In re Application of:
Jed Margolin
Application No. 08/587,731
Filed: January 19, 1996
For: A Method and Apparatus for
Remotely Piloting an Aircraft

INFORMATION DISCLOSURE STATEMENT

RESPONSE UNDER 37 C.F.R. § 1.116
-- EXPEDITED PROCEDURE --
EXAMINING GROUP 3614

Figure 7

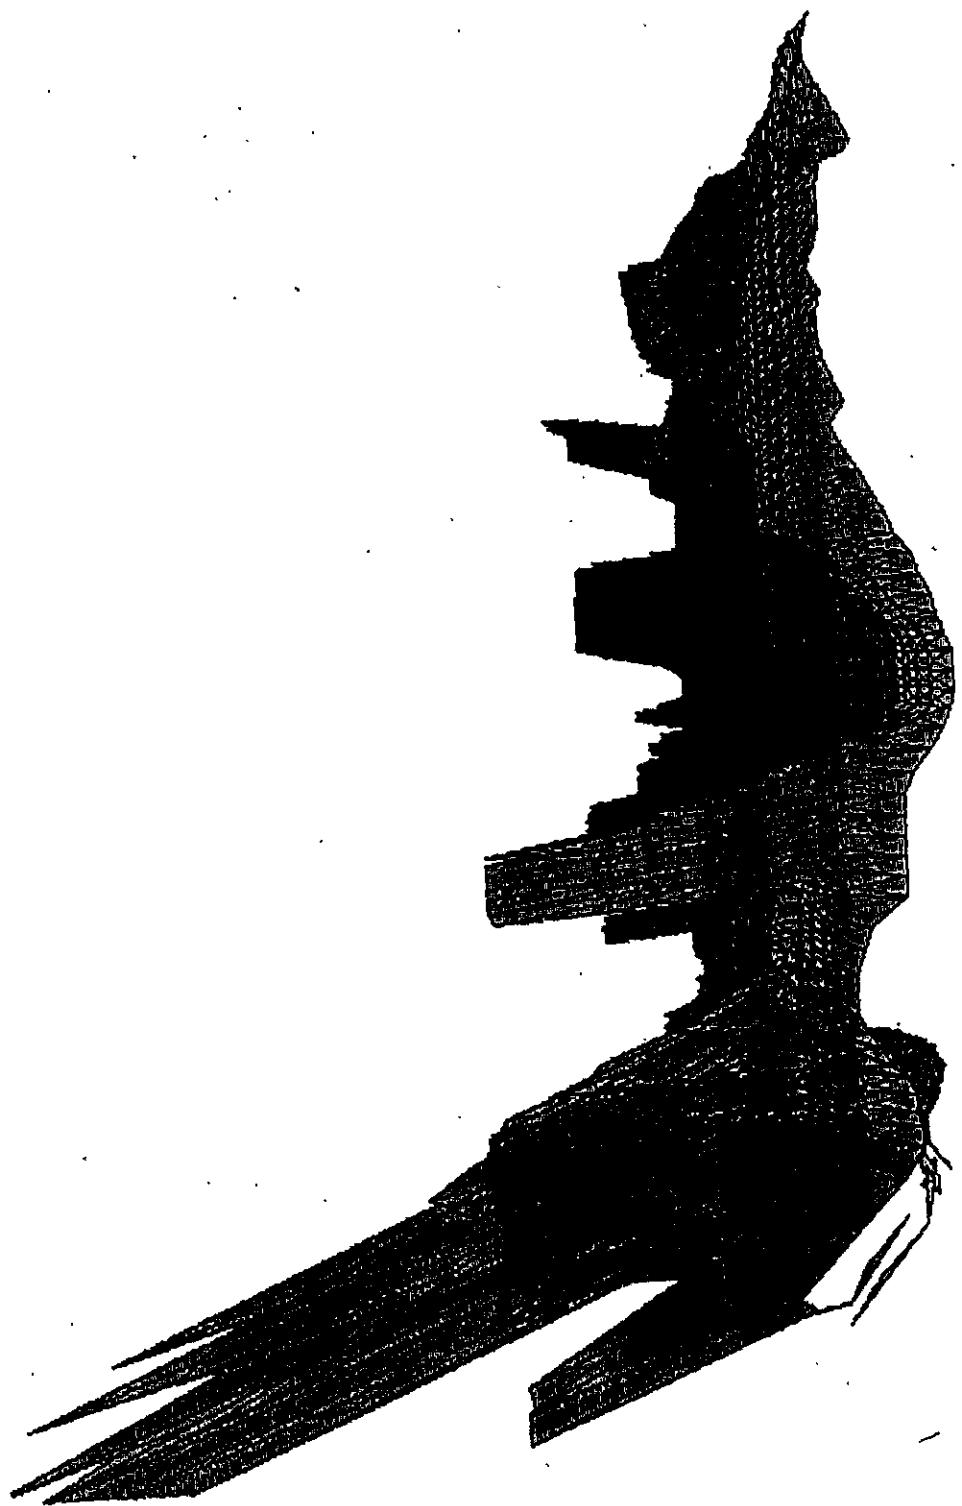
Applicant respectfully requests that the objection to the shading in Figure 7 be withdrawn because: 1) the shading aids in understanding the invention; and 2) the inventor has no other way of generating the figures. According to 37 C.F.R. 1.84(m) "the use of shading in views is encouraged if it aids in the understanding of the invention... Flat parts may also be lightly shaded. Such shading is preferred in the case of parts shown in perspective..." Figure 7 illustrates the projections that can be produced from the database in accordance with the invention. The shading is used for depth cueing, and therefore aids in the understanding of the invention by augmenting the perspective views provided.
